Doc or ECO #:	ECO-70160-002	Date:	06/28/2019	Author:	GD
	Rev. #:	A				
RF filter modification	Engineering Approval:	aeg	Date:	7/15/2019	Quality Approval	DO

P/N #:	70160	Effective Date:	July 15, 2019
Title:	RF filter modification

Finished modification

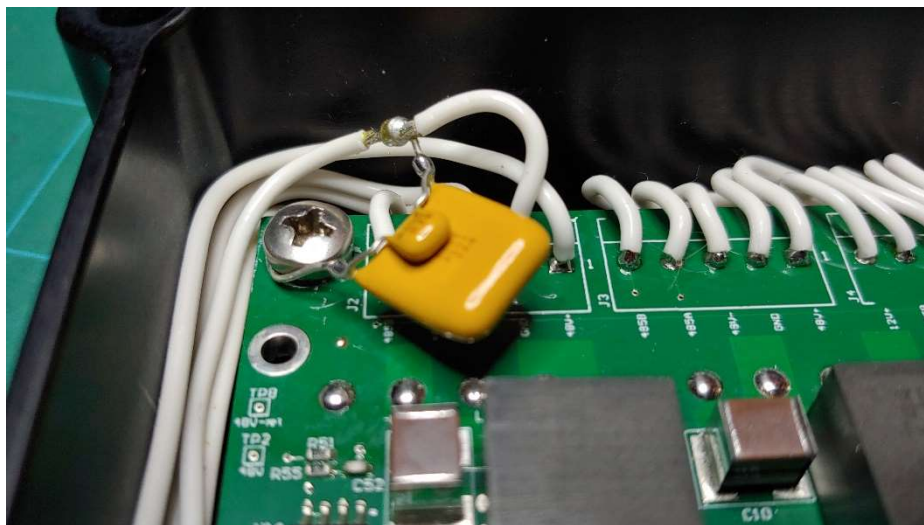
AC coupling filter caps were added to the power module to reduce interference, especially with respect to the DVL.

RF filter with two ceramic capacitors (0.1uF and 1uF) are needed to reduce electronic interference when a 500KHz DVL is attached as an accessory. Adding this RF filter will increase the Bottom Lock Range of DVL significantly.

The two capacitors 0.1uF and 1uF in parallel are added between Pin 5 port Ground (pin 2) and the housing

The next revision of the power board will include this modification on board.
